# Access Compliance Report

## Public Rights-of-Way

### (Curb Ramps)

Intersection ID: 10022037	Main Street: BRYANT_FARMS_RD	Cross Street: N/A	Location: SW
ADA ID: 90C23AA2EE7B	Ramp Type: BlendTrans1	Initial Pass/Fail: Fail	Overall Compliance: No
Severity Score: 8.75			
Codes/Mitigation Info/Possible Solution		Field Measurements/Component Compliance

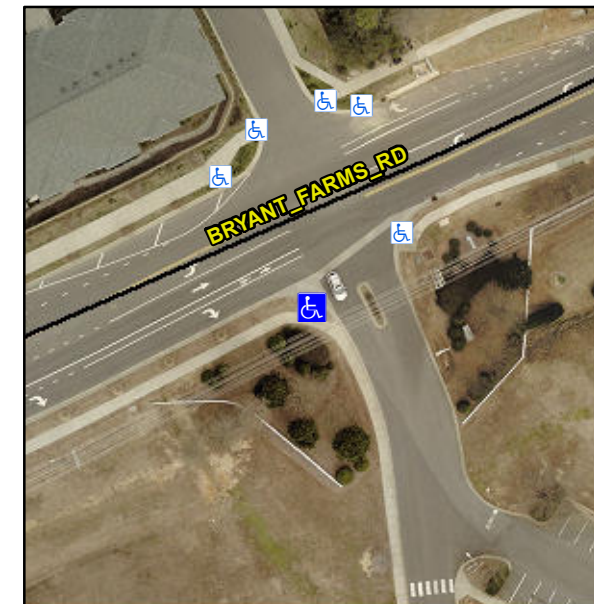
Compliance	Description	Data	Compliance	Description	Data
N/A	Ramp Length (in)	89.0	Yes	BlendTrans Slope (%)	1.1
No	Ramp Width (in)	47.0	Yes	BlendTrans XSlope (%)	0.2
N/A	Flare Type LT	N/A	N/A	Flare Type RT	N/A
N/A	Flare Slope LT (%)	N/A	N/A	Flare Slope RT (%)	N/A
N/A	Flare Traversable LT?	N/A	N/A	Flare Traversable RT?	N/A
N/A	Landing Length (in)	N/A	N/A	DWS Provided?	N/A
N/A	Landing Width (in)	N/A	N/A	DWS Contrast?	N/A
N/A	Landing Slope (%)	N/A	N/A	DWS Length (in)	N/A
N/A	Landing X Slope (%)	N/A	N/A	DWS Full Width?	N/A
N/A	Landing Curb? (Y/N)	N/A	N/A	DWS Offset (in)	N/A
N/A	Shared Landing?	N/A			
N/A	Gutter Ponding?	N/A	N/A	Gutter Slope (%)	N/A
N/A	Gutter Lip Ht (in)	N/A	N/A	Gutter X Slope (%)	N/A
N/A	Painted X Walk1?	No	N/A	Painted X Walk2?	No
	X Walk 1 Direction	To NE		X Walk 2 Direction	To NW
	X Walk 1 Width (in)	N/A		X Walk 2 Width (in)	N/A
	X Walk 1 Slope (%)	0.9		X Walk 2 Slope (%)	0.2
	X Walk 1 X Slope (%)	0.2		X Walk 2 X Slope (%)	2.2

N/A	Ramp inside XWalk1?	N/A	N/A	Ramp inside XWalk2?	N/A
	Road Slope (%)	0.9		Clear Space?	N/A
	Road X Slope (%)	1.9	N/A	Clear Space to XWalk (in)	N/A
N/A	Any Obstructions?	N/A	N/A	Storm Grate/Utility Hazard?	N/A
	Obstruction Type			Storm Grate/Utility Type	
		N/A			N/A
			Yes	Surface Condition? (G/P)	Good
			N/A	Curb Slope (%)	3.0

**Remove & Replace Curb Ramp With Two New Directional Ramps or Equivalent.**

**R304.5.1**
